PETERSBURG BOAT HARBOR FACILITIES

PROJECT NO. W-65158

CHANGE ORDER #1
Petersburg Boat Harbor Facilities

SCALE As Shown
DATE April 27/65
PROJ. NO. 65158

APPROACH & PROFILE
scale 1" = 5'

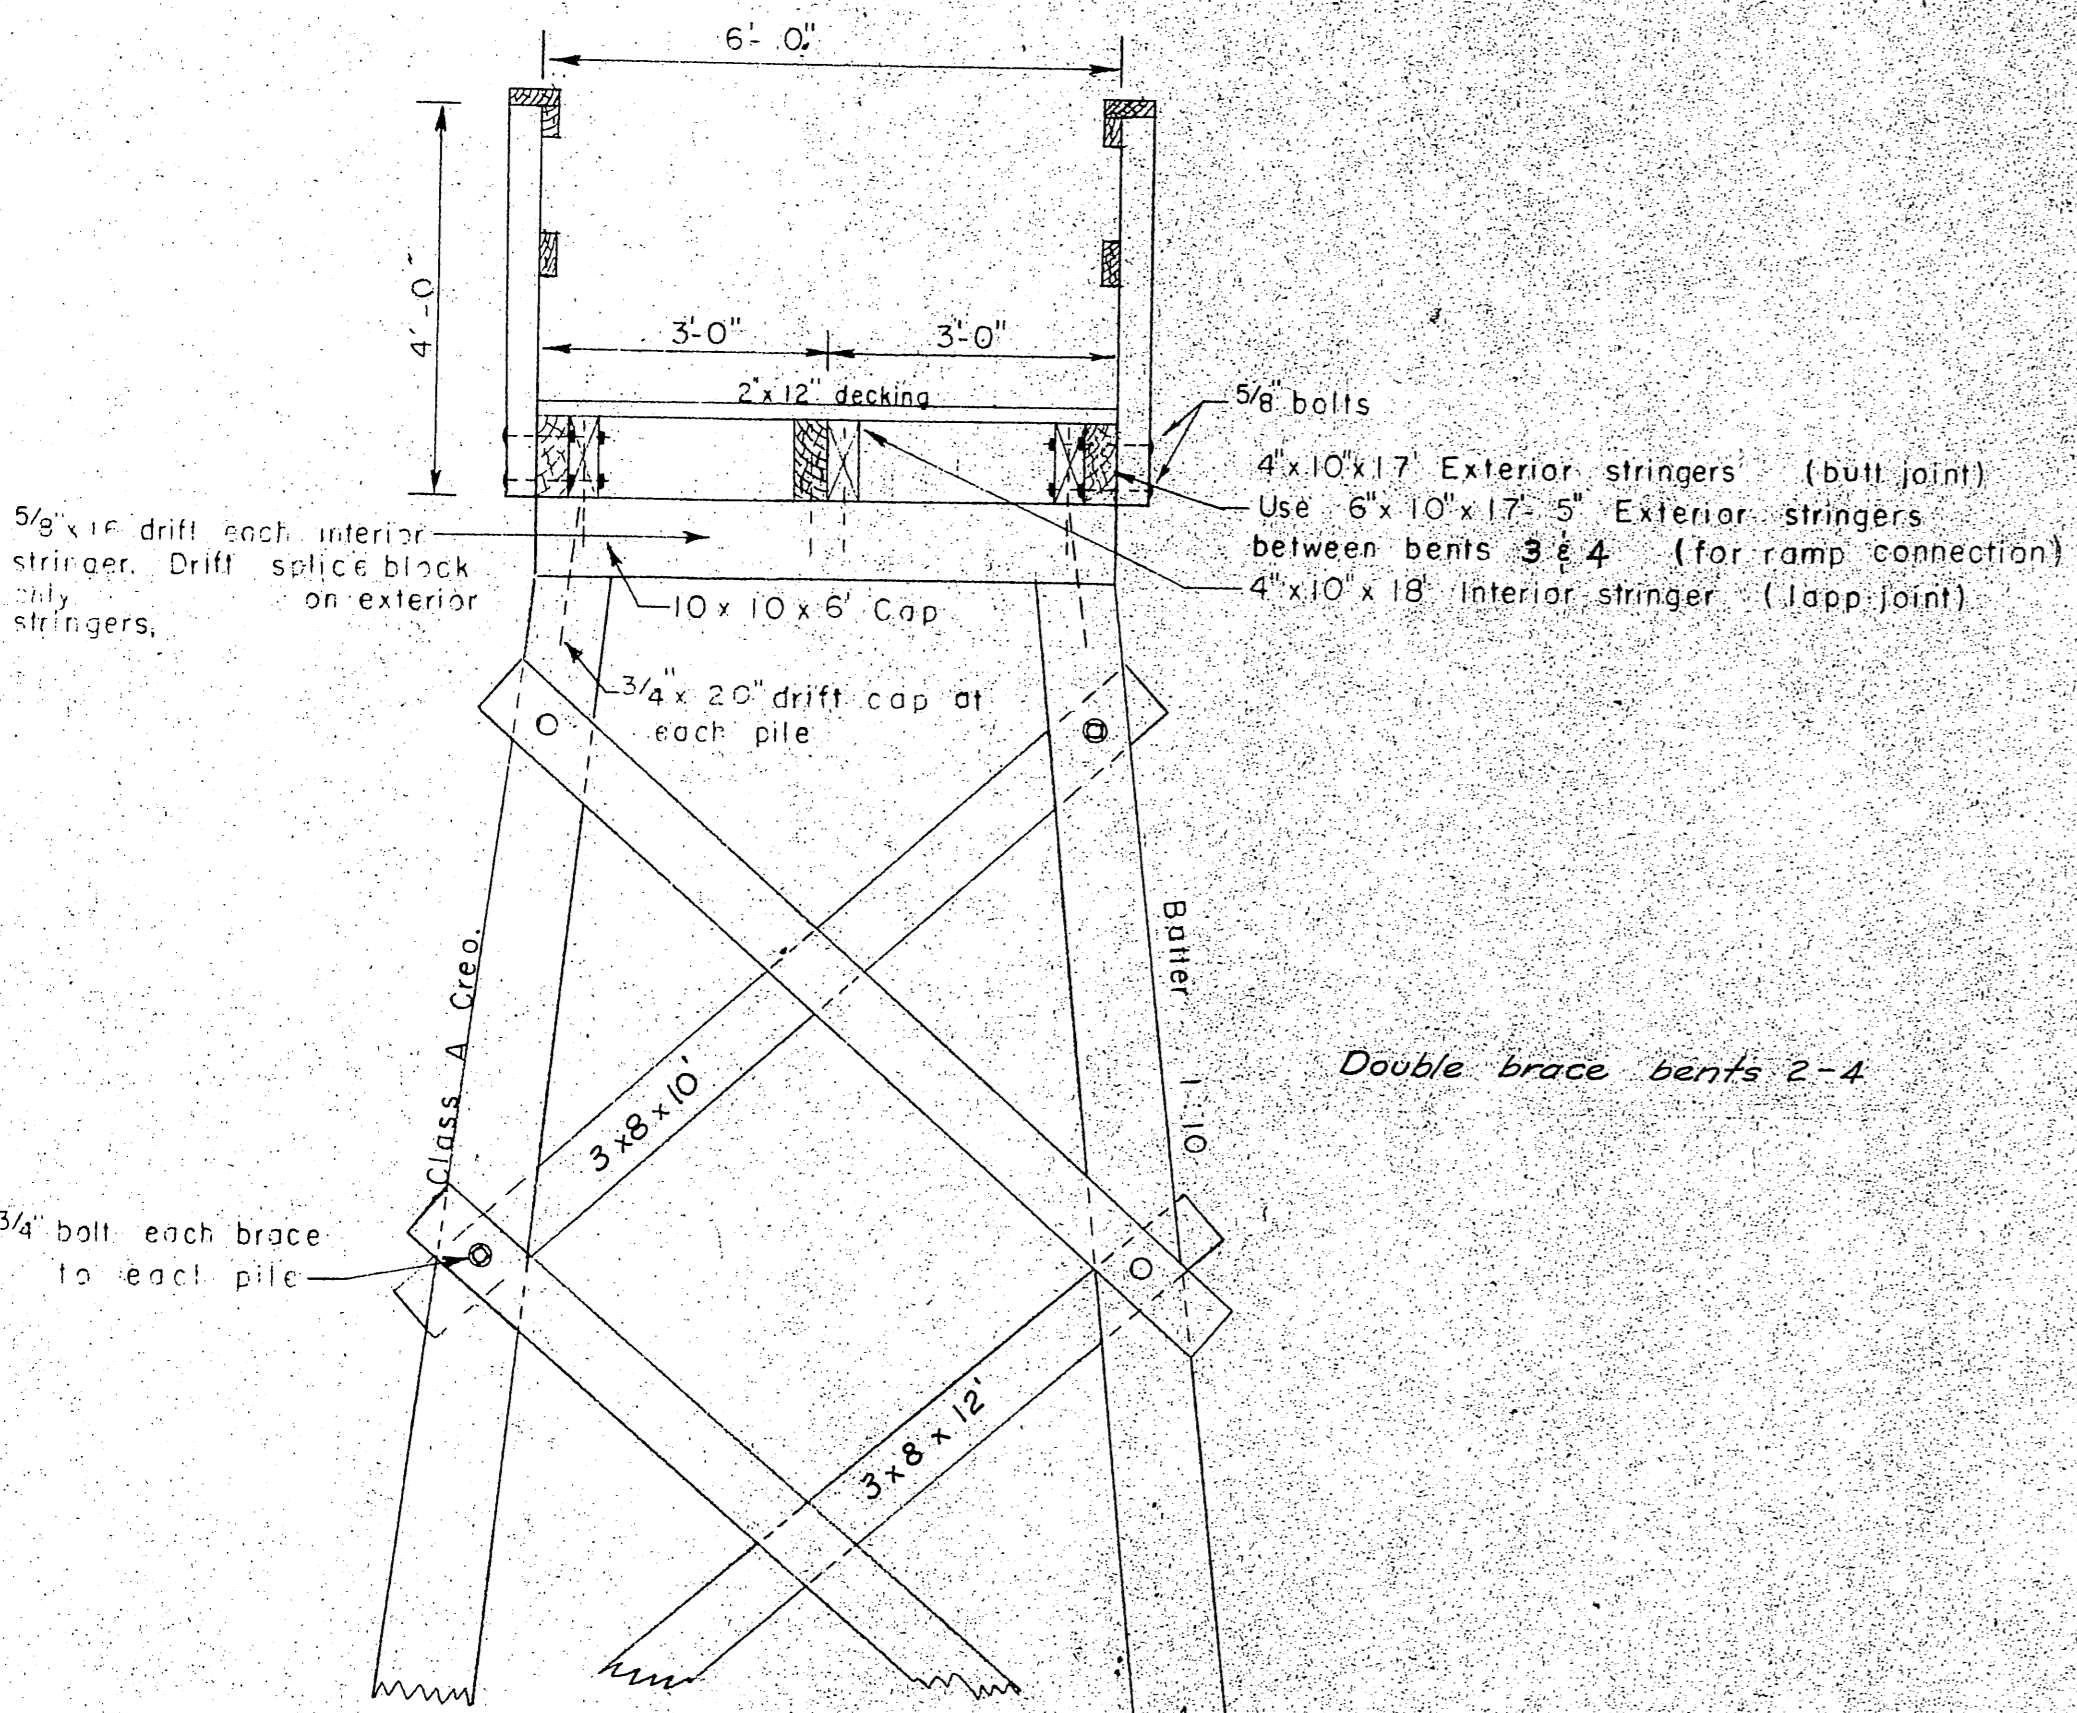
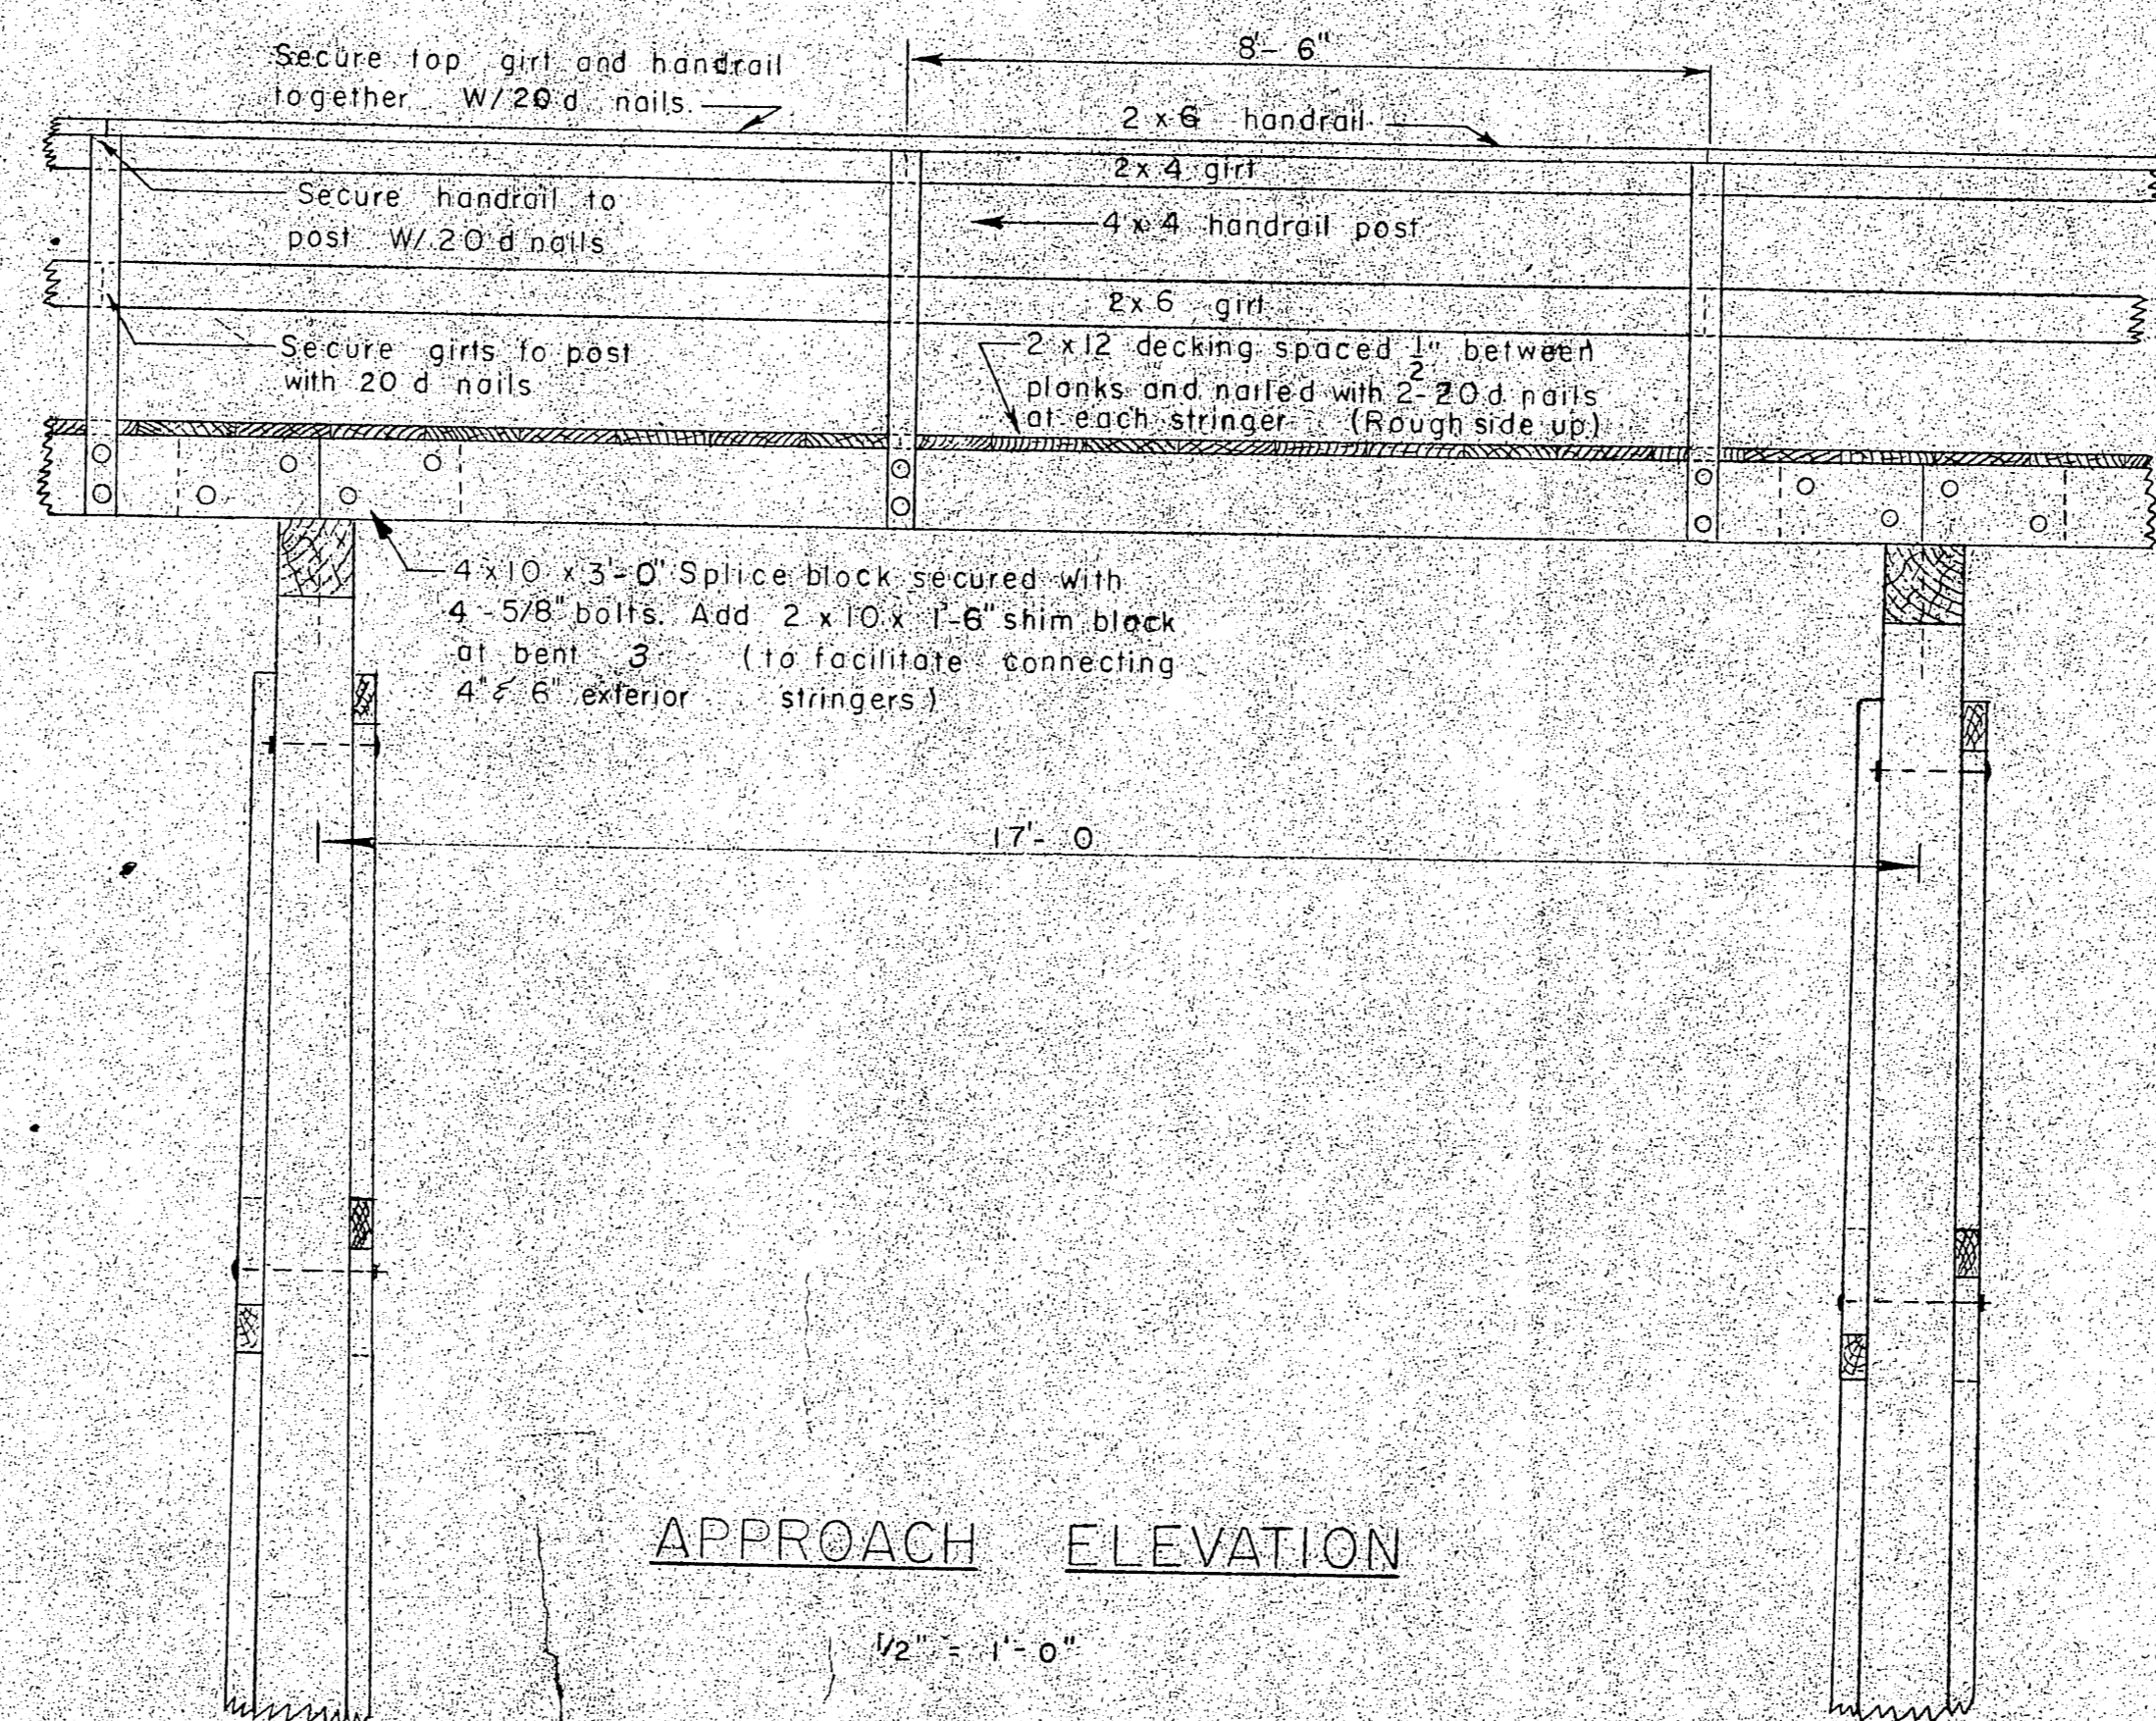
1. Vertical distances given are from deck to ground line.
2. Piling to be driven tip down to 15' penetration or refusal as determined by the Engr.
3. Provide and install 8 pieces of longitudinal bracing as noted between bents 2-3-4.

MODIFIED PONTOON SECTION AT STEEL GANGWAY
Scale 1/2" to 1'-0"

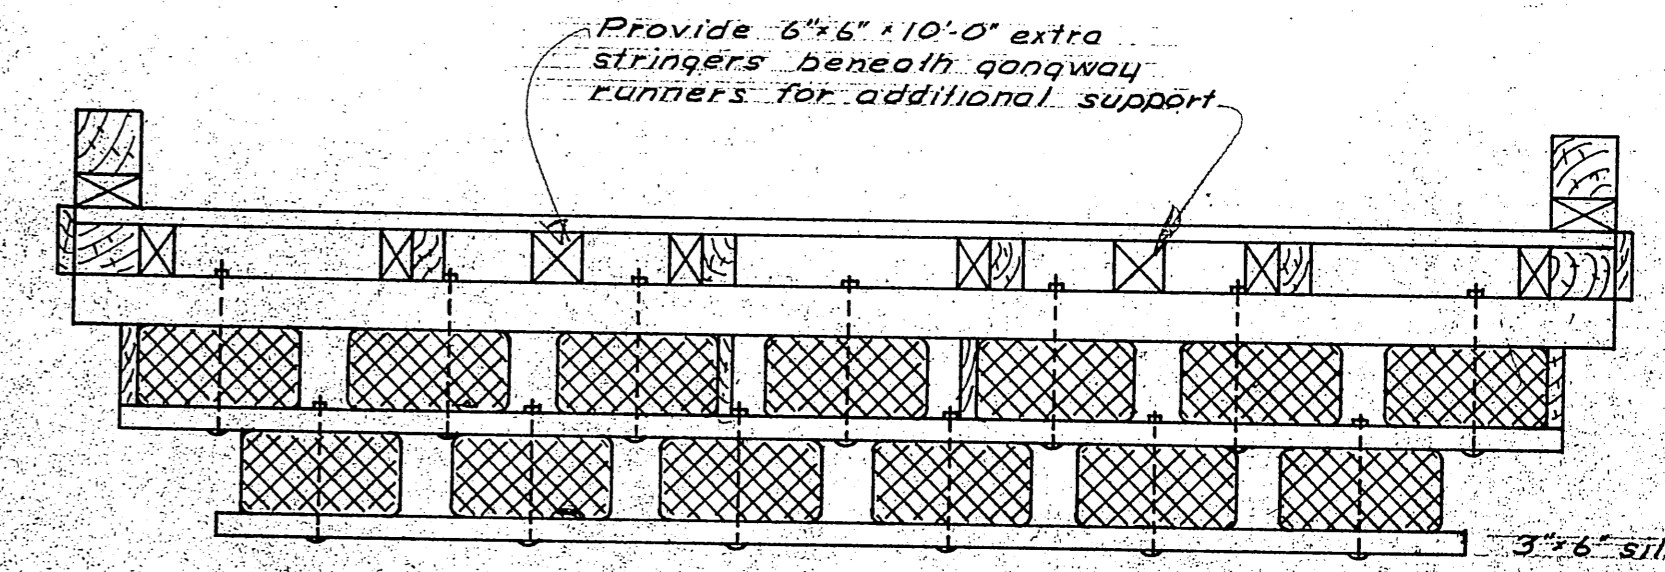
Provide 8 additional billets to provide extra flotation as shown.

Provide 2"x10"x10'-0" members for compression support
